REVISED AGENDA
WOODLAND PARK PLANNING COMMISSION
Thursday, December 14, 2023, 6:30 P.M.
Council Chambers – 220 W. South Avenue

Planning Commission Staff Report Public Hearing December 14, 2023

CUP/SPR2023-034 Pikes Peak Taco CUP/SPR: A request by Pikes Peak Taco, Mexican Restaurant, Inc. (applicant) and Morales Enterprises, LLC (property owner) for a Conditional Use Permit with a Site Plan Review to accommodate a drive-thru Mexican restaurant and associated site improvements along with a common lot $\frac{3}{4}$ driveway off Highway 24 with a legal description of Lot 3, Brecken Heights (19569 E. US 24) in the Community Commercial (CC) zone. (QJ)

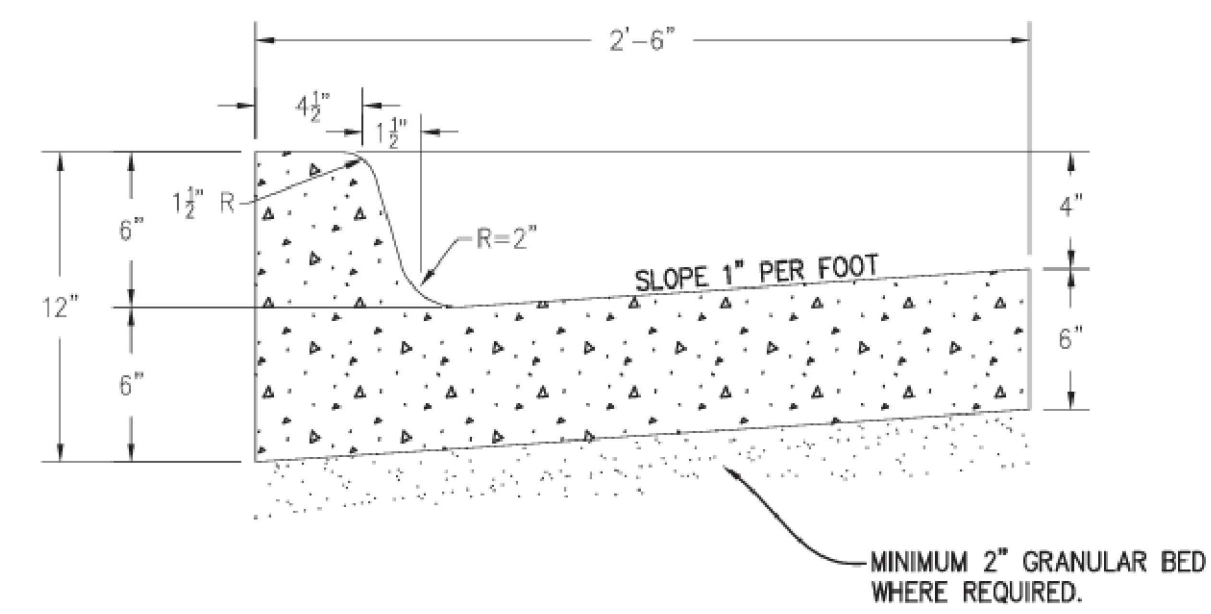
PROVIDE TRANSFORMER LOCATION AND METERING LOCATION
MEET CORE REQUIREMENTS - SEE ATTACHED BUILDER HANDBOOK
